# Townson Road Upgrade between Jersey Road and Burdekin Road – Stage 2

Submissions report  
January 2024

Figure 3.3: Option 2

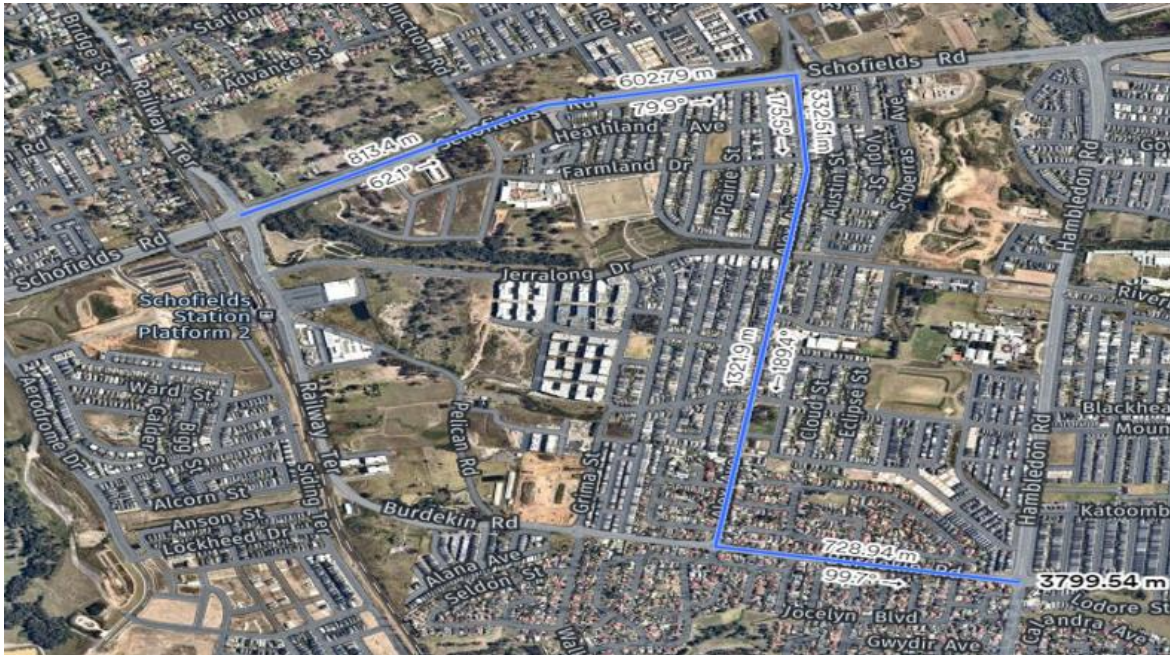
Option 2 traverses the road from Schofields Road / Railway Terrace via Schofields Road, Alex Avenue, and Burdekin Road to the Hambledon Road intersection. The approximate distance along this route is 3.8 kilometres.

Figure 3.5: Traffic journey times

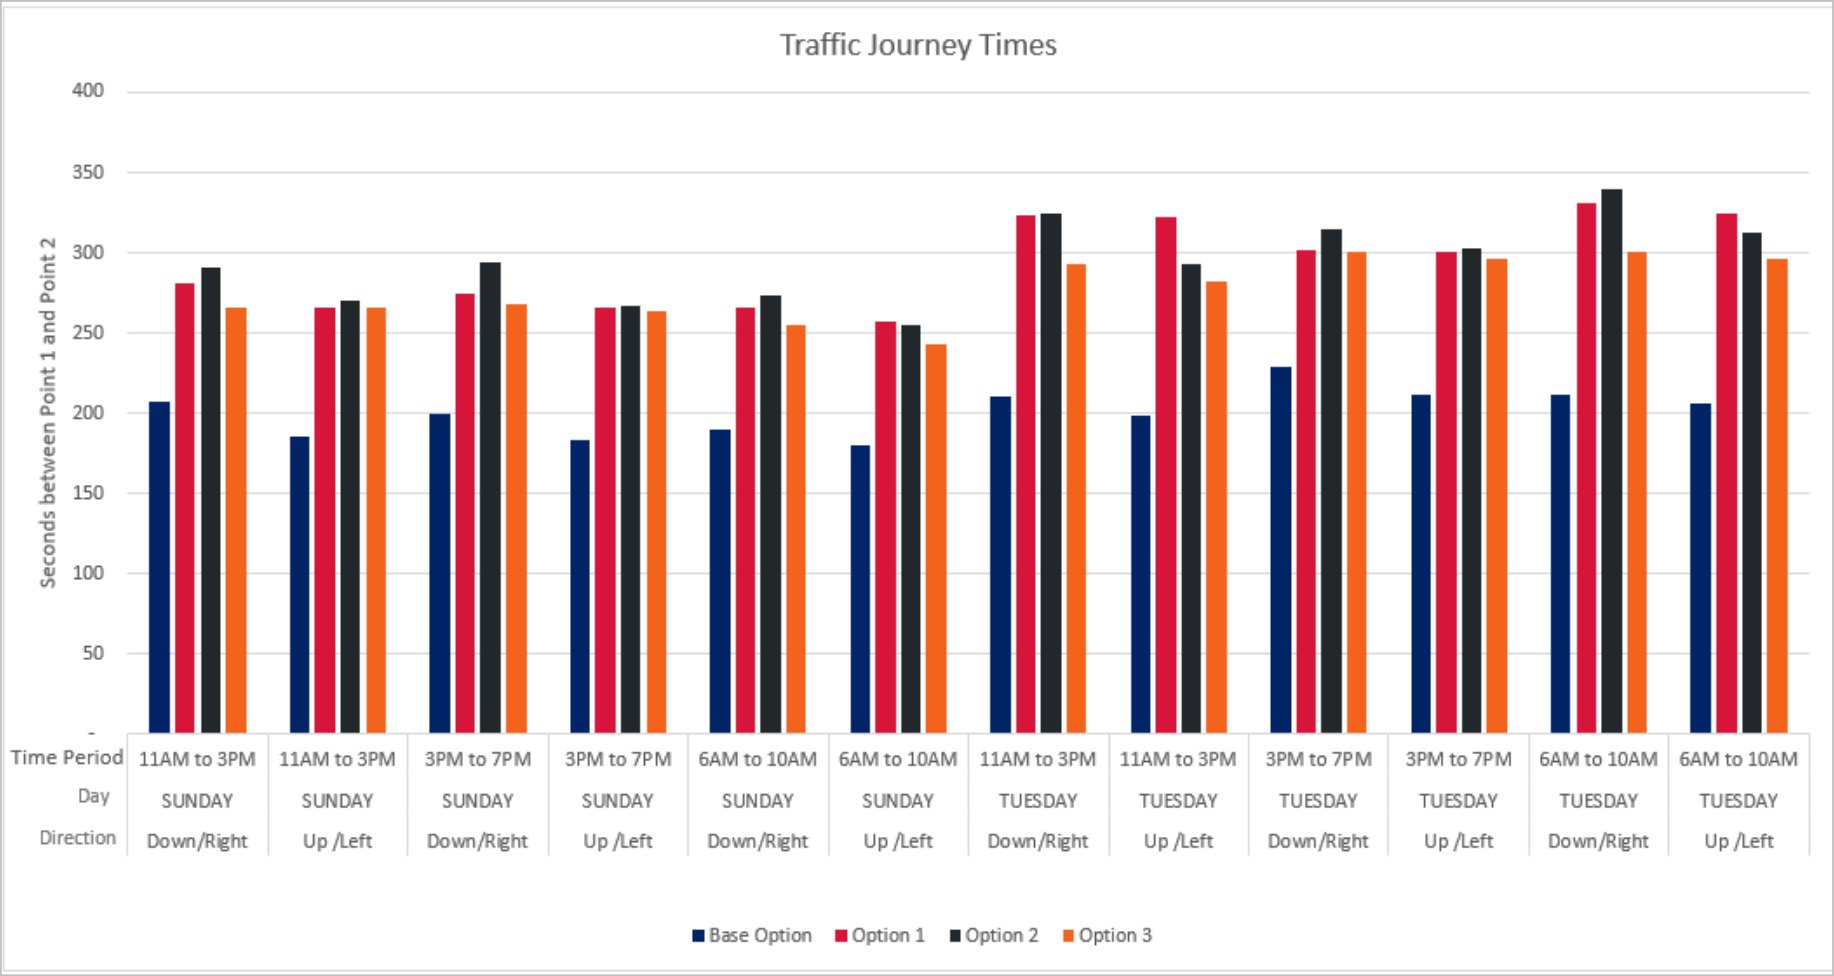
The predicted journey times following the closure of Railway Terrace south of Stoke Street are shown in Table 3.1 and Figure 3.5.

The results show that all three alternative routes will result in an increased journey time for either day and for the measured time periods when travelling between the Schofields Road/Railway Terrace intersection and the Hambledon Road/Burdekin Road intersection.

The predicted journey times in Table 3.1 show the smallest change on a weekend day (Sunday) via Option 3 requiring an additional 58 seconds travelling time around midday while the largest change is via Option 2 requiring an additional 94 second travelling time during the later afternoon/ evening period.

The journey times measures in Table 3.1 show the smallest change on a weekday (Tuesday) is via Option 3 which results in an additional 72 seconds traveling right/down (3PM to 7PM). The largest change is via Option 2 with an additional 128 second travelling right/down (6AM to 10AM).
